REVISED RESPONSE TO REQUEST FOR ADDITIONAL INFORMATION**APR1400 Design Certification****Korea Electric Power Corporation / Korea Hydro & Nuclear Power Co., LTD****Docket No. 52-046**

RAI No.: 38-7878
SRP Section: 07.05 – Information Systems Important to Safety
Application Section: 7.5
Date of RAI Issue: 06/18/2015

Question No. 07.05-01

Figure 7.5-1 Diverse Display of Accident Monitoring Type B and C Variables

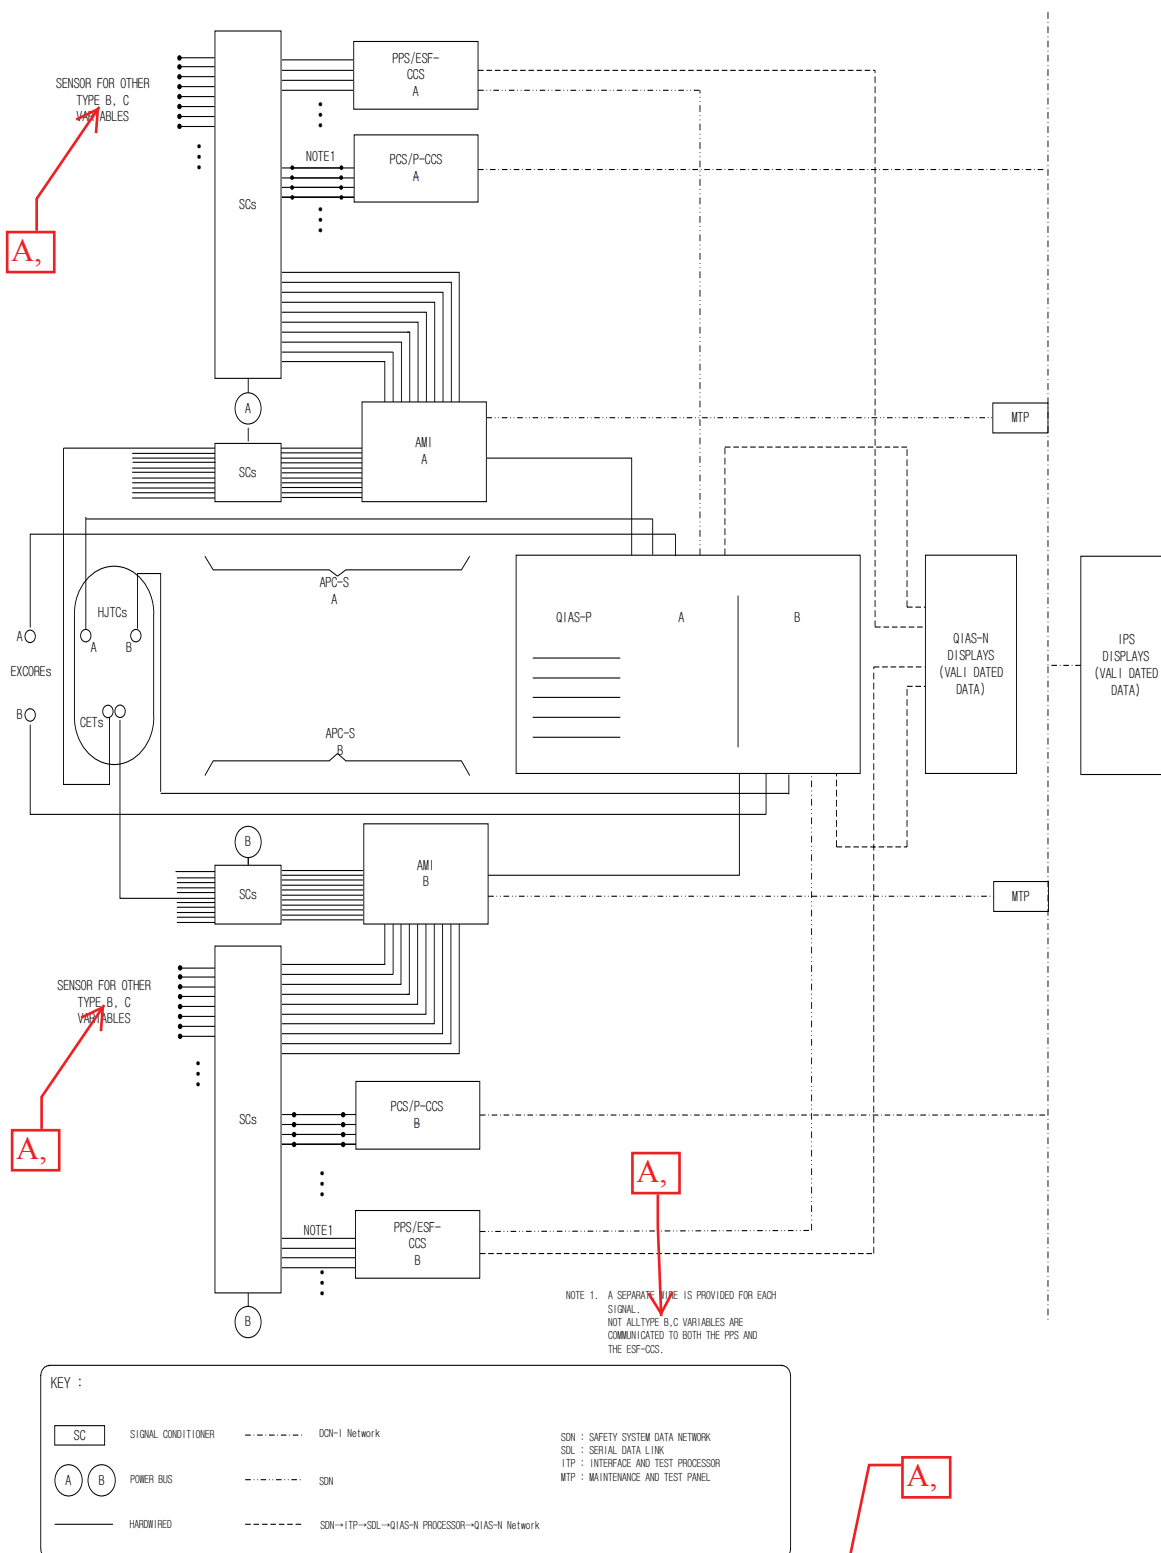
The AMI is designed to meet the guidance of NRC Regulatory Guide (RG) 1.97 (Reference 1), as depicted in Figure 7.5-1 and as follows:

- a. The qualified indication and alarm system - P (QIAS-P) is dedicated to continuously monitor and display AMI Type B and C variables. ~~There are no AMI Type A variables in APR1400 design.~~ The QIAS-P in each division (A or B) has one flat panel display, which is mounted on a safety console in the MCR.
- b. The qualified indication and alarm system - non-safety (QIAS-N) is designed to support continuous plant operation if the information processing system (IPS) becomes unavailable. The function of the QIAS-N also includes displaying AMI Type B, C, and selected sets of Type D and E variables.
- c. The IPS provides displays for all AMI variables. The IPS also has a historical data storage, retrieval, and trending capability.
